# Access Compliance Report

## Public Rights-of-Way

| Intersection ID: 44173                  | Main Street: BELLEGARDE_DR | Cross Street: BOBHOUSE_DR               | Location: SE           |
| ADA ID: 59E0F546ECAB                    | Ramp Type: PerpDiag        | Initial Pass/Fail: Fail                 | Overall Compliance: No |

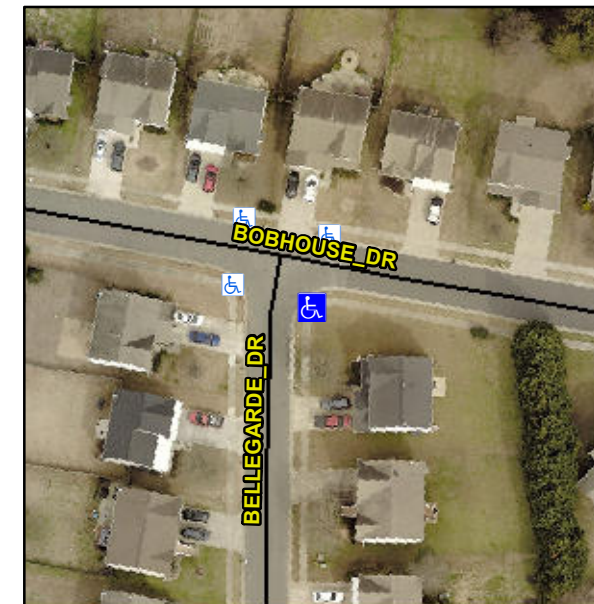
**R304.5.1, R304.2.2**

| Compliance | Description           | Data  | Compliance | Description                 | Data  |
|------------|-----------------------|-------|------------|-----------------------------|-------|
| N/A        | Ramp Length (in)      | 49.0  | No         | Ramp Slope (%)              | 10.5  |
| No         | Ramp Width (in)       | 38.0  | Yes        | Ramp XSlope (%)             | 1.8   |

**Remove & Replace Curb Ramp With Two New Directional Ramps or Equivalent.**
